NP-12-0021
May 31, 2012

Subject: Exelon Nuclear Texas Holdings, LLC
Victoria County Station
Early Site Permit Application
Environmental Report – Response to ER RAI Letter No.5
Docket No. 52-042

ESP EIS 9.3.1-1 (eRAI No.6394, RAI Letter No. 5):**NRC Request:**

Figure 1 ERCOT Map with Depiction of Adequate Water Areas

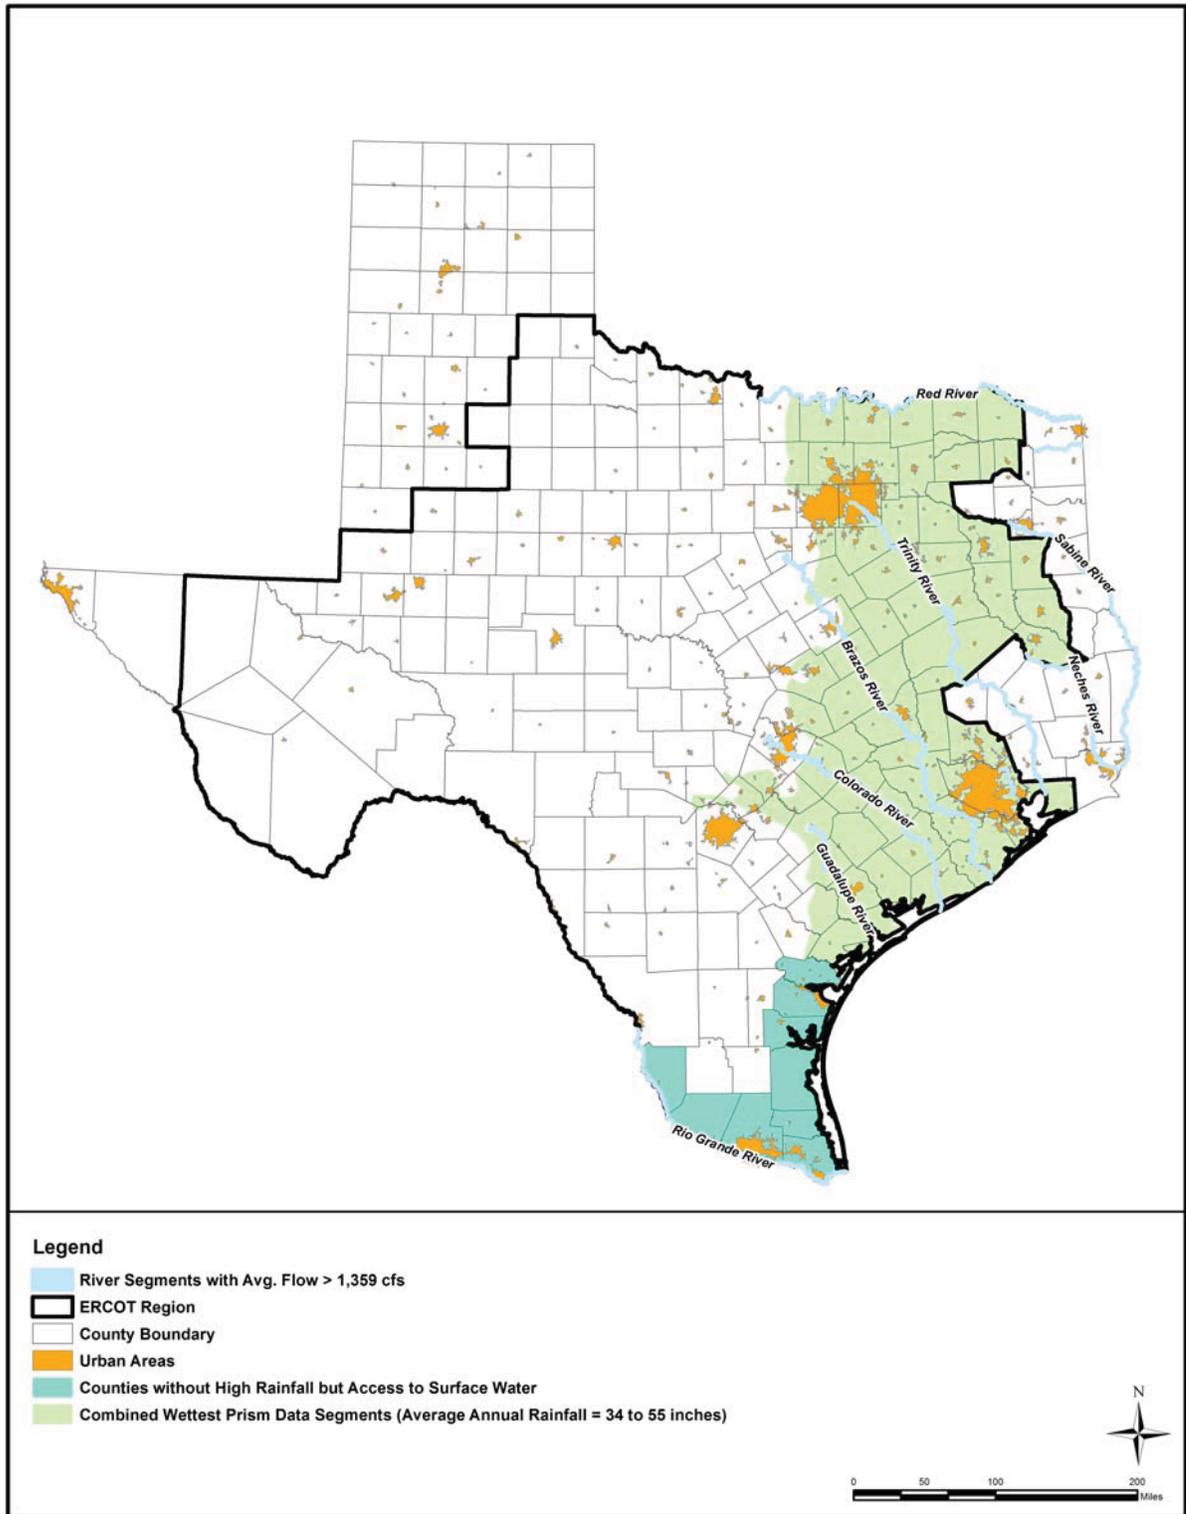
The ESRP Section 9.3 requires NRC to review the process by which the applicant has identified and evaluated alternative sites for the proposed action. Details of the applicant's site selection methodology must be available to support the NRC's evaluation of its reasonableness and to make sure that there is no other site that is obviously superior to the one being proposed by the applicant. This requires an analysis of alternative sites to support the determination of whether there is an obviously superior site in terms of overall environmental impacts and costs when compared to the site proposed by the applicant. Selection of candidate areas was separate from identifying and evaluating candidate sites and sufficient details of the decision-making process were not provided in the ER. Provide a discussion regarding the manner in which the candidate areas in the site selection process for the alternative sites were identified. Include all of the factors that influenced these selections and the values assigned to each criterion.

To verify that the “adequate water area” selected using the PRISM data was consistent with the site selection estimate of 61,000 gpm (135.9 cfs), Exelon analyzed surface water flow characteristics for major rivers in Texas using GIS data compiled by the U.S. Geological Survey (USGS 2003). Specifically, USGS gaging stations with an average daily stream flow greater than 10 times the estimated maximum consumption rate for the project (or average flow greater than 1,359 cfs) were identified. Applying a flow rate of 10 times the project requirement resulted in identifying river segments that have the physical availability of water to supply the new facility and a reasonable potential to acquire the necessary cooling water supplies. The gaging station most upstream on each major river meeting the flow requirement was identified as the point below which the river possesses sufficient flow to be identified as a viable cooling water source. The major rivers were then split into two segments at these locations: the upstream segment not meeting the flow requirement, and the downstream segment meeting the flow requirement. The river segments meeting the flow requirement are depicted in Figure 1, along with the adequate water area defined using the PRISM data.

Figure 1 indicates good correlation between the major river segments with sufficient flow and the wettest areas from the PRISM dataset, confirming the selection of the adequate water area. Figure 1 also shows that the lower portion of the Rio Grande River basin appears to have adequate physical water availability to support a new nuclear facility. Despite low average annual precipitation in the southern portion of Texas, the large size of the Rio Grande River watershed (approximately 176,000 square miles of contributing area) results in the observed average flow rates (RGRWPG 2006). Accordingly, counties in the lower Rio Grande basin were retained for further consideration.

Coastal counties not already within the adequate water area determined from the PRISM data were also examined as potential sites for saltwater cooled plants (see Figure 1).

Figure 9.3-2a. Counties Remaining After Application of Exclusion Criteria

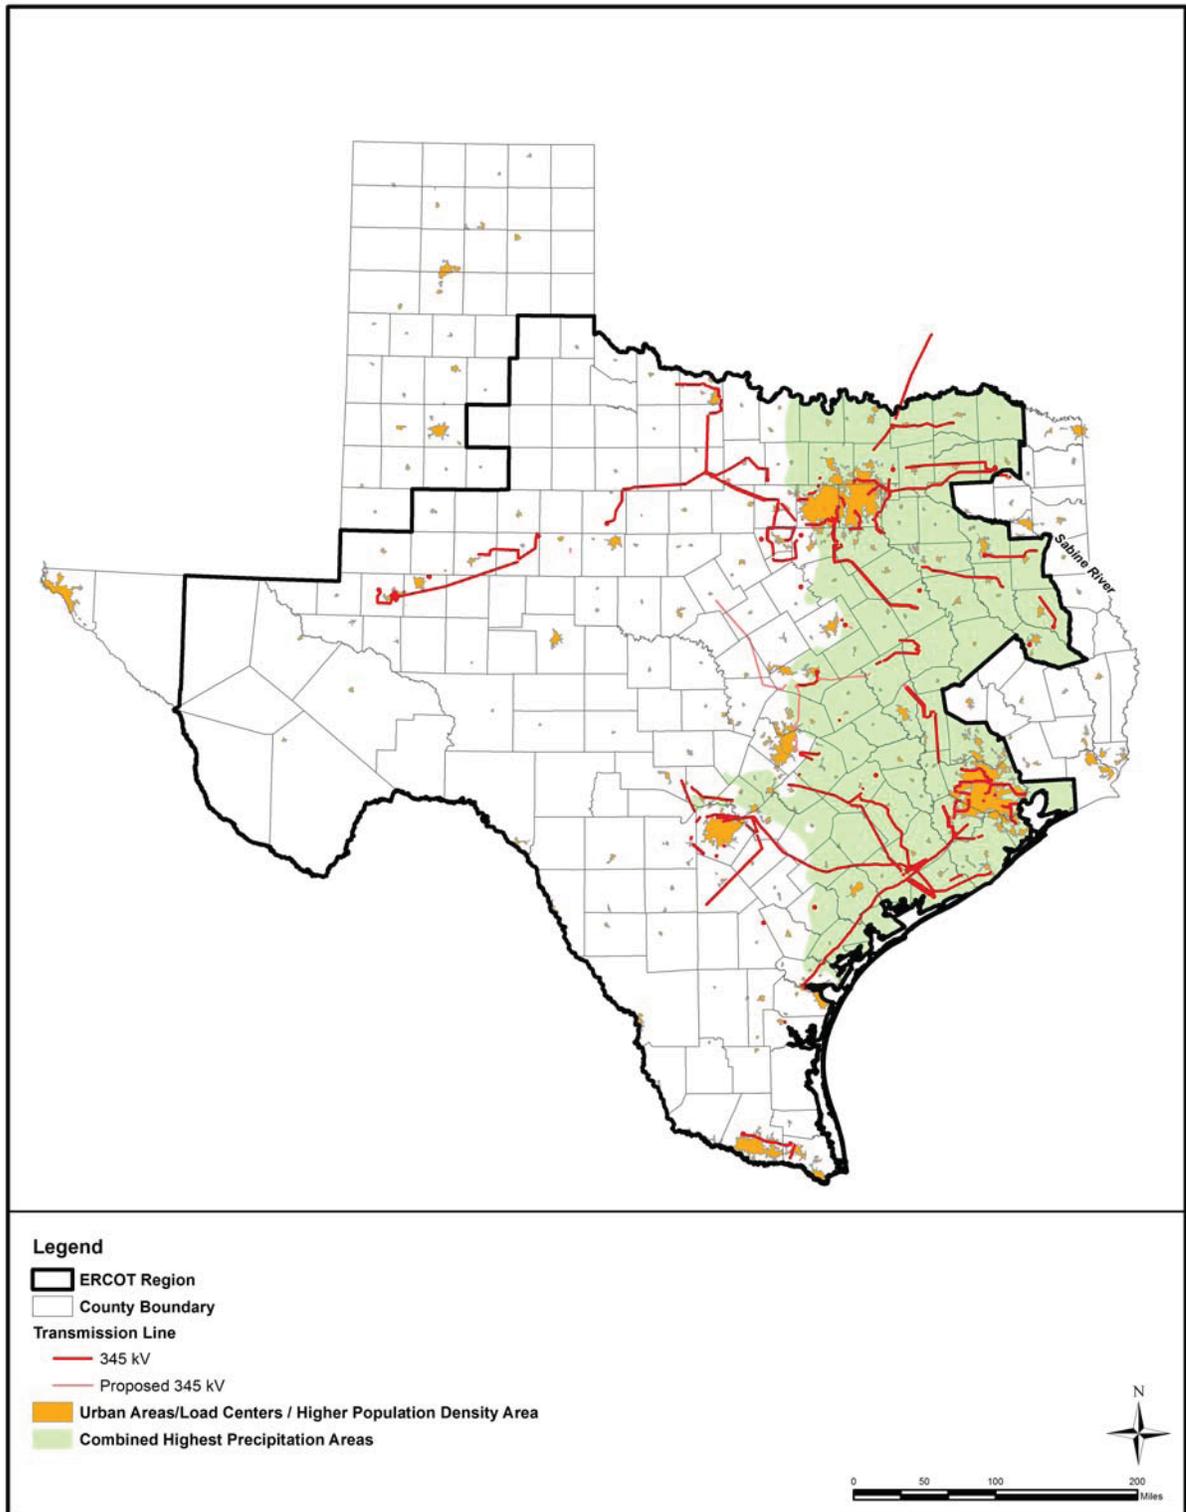
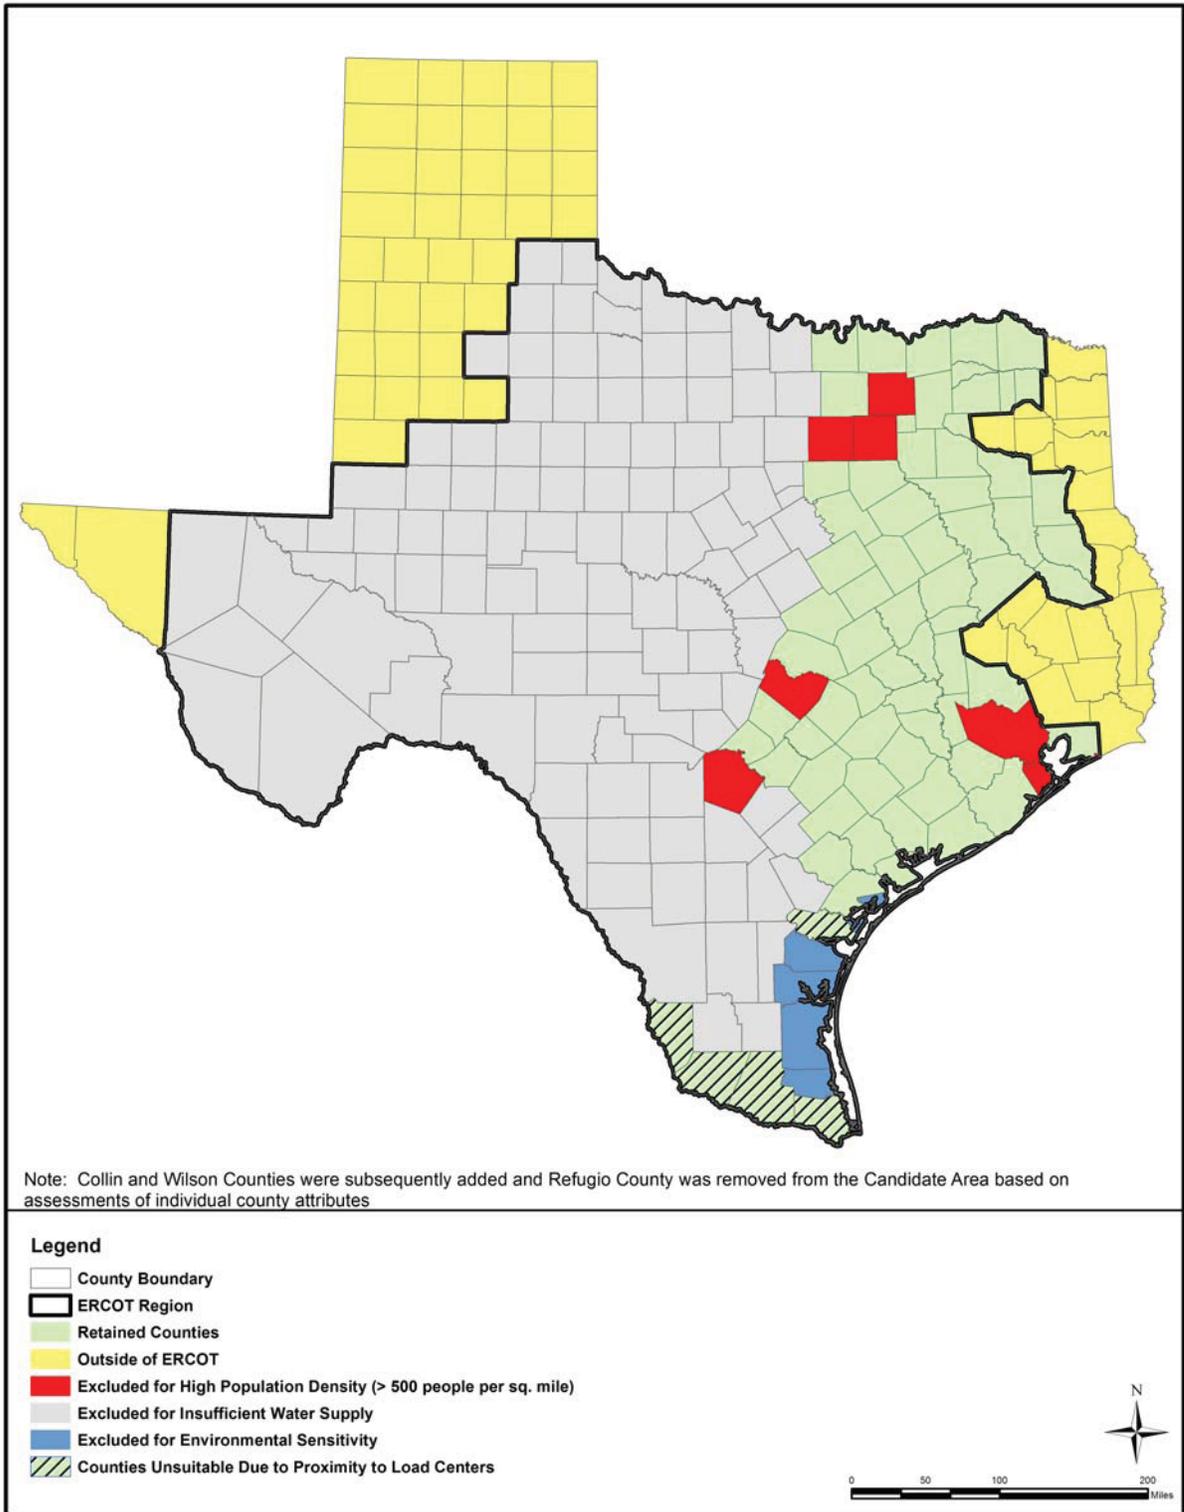
Figures 9.3-2 and 9.3-3 will be replaced with Figures 9.3-2a, 9.3-2b, and 9.3-3 in a future revision as indicated below.

Application of the above exclusionary and suitability criteria yielded two a candidate areas of 66 counties viewed to be favorable for the ESP project, ~~as shown in~~ Figures

9.3-2a and 9.3-2b summarize the application of exclusionary and suitability criteria during Candidate Area selection. Figure 9.3-3 presents the Candidate Area counties.
